GILMORE & ASSOCIATES, INC.
ENGINEERING & CONSULTING SERVICES

February 3, 2022

Reference: Final Land Development Plan Review - 7th Review
Steelworks
Tax Map Parcel Number: 15-9-82 to 15-9-90

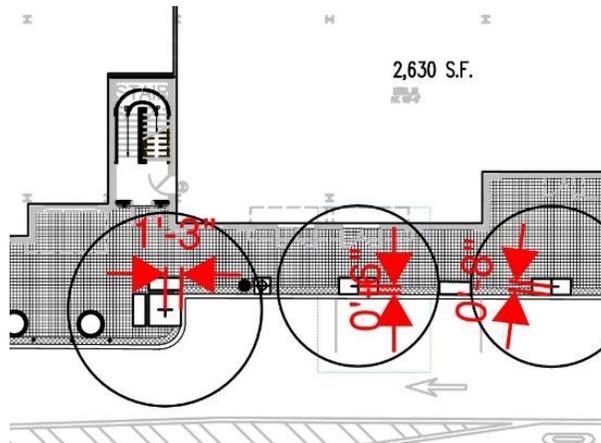
- c. As per Tree Manual, section 8.00.B.1(c)1, large trees, defined per the Phoenixville Tree manual as attaining a height of forty-five (45) feet or more with spread of thirty (30) feet or more, shall be planted at

least 2-1/2 ft away from concrete curb, and sidewalk. The proposed street trees appear to be planted less than 2-1/2 ft away from sidewalk and concrete curb. Tree grate should be enlarged to accommodate this requirement, where feasible, or relief would be required.

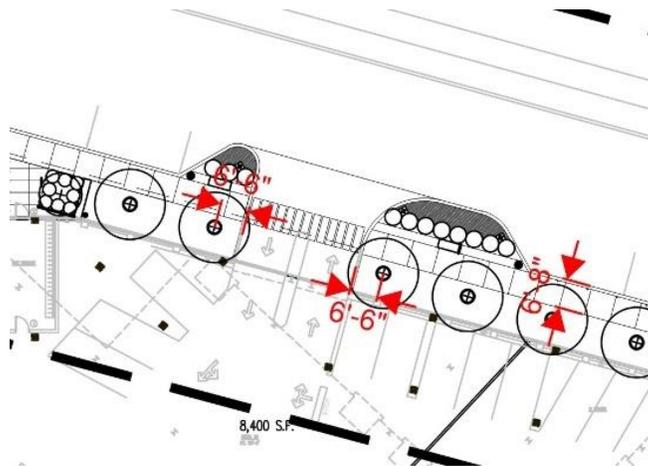
- d. As per Tree Manual, section 8.00.C.2(b), no tree shall be planted with-in ten (10) feet of the access drive for any non-residential building or off-street parking lot. Proposed trees appear to be planted less than 10 feet from the access drive to the parking areas along the Hall Street extension. Future submissions should be revised to comply with this requirement, or relief would be required.
